**RE: RESPONSE TO SUBMISSIONS
FORT STREET PUBLIC SCHOOL (SSD-10340)**

The Environmental Impact Statement (EIS) for Fort Street Public School (FSPS) was publicly exhibited for a period of 28 days, concluding on 29 April 2020. During the exhibition, eight submissions were received from government agencies, six submissions were received for non-government organisations and ten submissions were received from members of the public. An additional five submissions were received after the exhibition period ended.

Figure 1 Phase 1 Student Drop-off and Pick-up

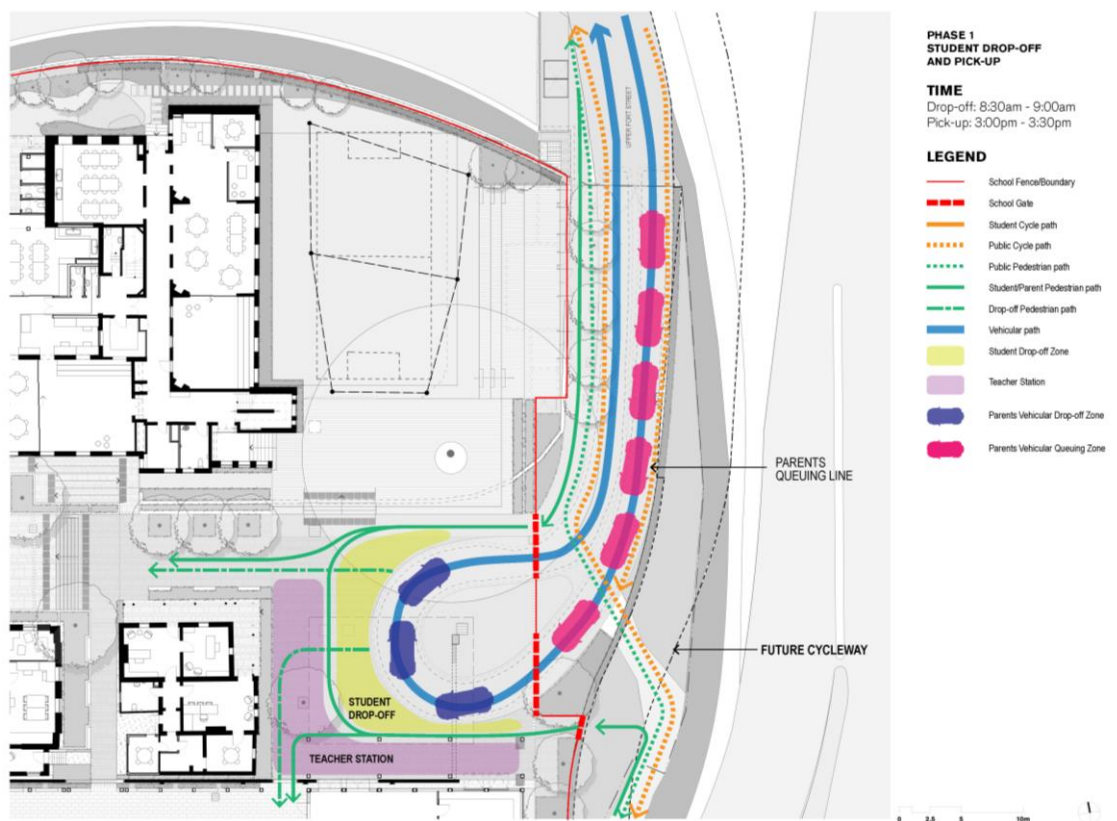
The City of Sydney and the FSPS P&C raised concerns over the design of the school's entrance at Upper Fort Street and safety of young children and cyclists. Specific concerns included:

- The highly constrained nature of the school entrance will give rise to potential conflict created between vehicles, students and cyclists during drop-off and pick-up (DO/PU) times;
- Potential congestion and safety incidents resulting from the proposed cul-de-sac U-turn arrangement;
- Proposed school entrance does not allow for waste collection in a forward direction only; and
- Waste collection and DO/PU should be done on Upper Fort Street and not within the school playground.

DO/PU operations will occur via a single U-turn manoeuvre turnaround provided in the main forecourt of the school. The school gates located at the boundary of the main forecourt will be opened strictly between 8:30am-9:00am for drop-off, and between 3:00pm-3:30pm for pick-up. **Figure 1** below shows the proposed Phase 1 DO/PU arrangements and interface with pedestrians and cyclists.

During DO/PU, there is sufficient space in the main forecourt for three large cars to safely complete their DO/PU manoeuvres. The areas for cars will be delineated through pavement types that are continuous from Upper Fort Street. Up to 30 cars will be able to queue along Upper Fort Street, with an additional overflow queue on Watson Road capable of accommodating 18 cars.

A pedestrian path that provides access into the school will be provided on the western side of Upper Fort Street for students, parents and public pedestrians. The alignment of the path on the western side of Upper Fort Street ensures that students and parents will not be crossing the street in front of queueing cars. Public pedestrians will need to cross Upper Fort Street.

Cyclists travelling south will use the eastern lane of Upper Fort Street alongside the queueing cars. Cyclists travelling north will need to cross Upper Fort Street and use the western lane. It is anticipated that the majority of cyclists mixing with traffic flow will occur during the morning drop-off period when the cycleway is busiest with morning commuter cyclists. This is less likely to occur in the afternoon pick-up period as bicycle traffic is significantly lower than in the commuter peaks. Whilst the cyclists will mix with traffic flow, the queueing vehicles will either be

stationary or moving slowly. As such, this does not present a major safety risk and can be readily managed through signage and education of parents and cyclists.
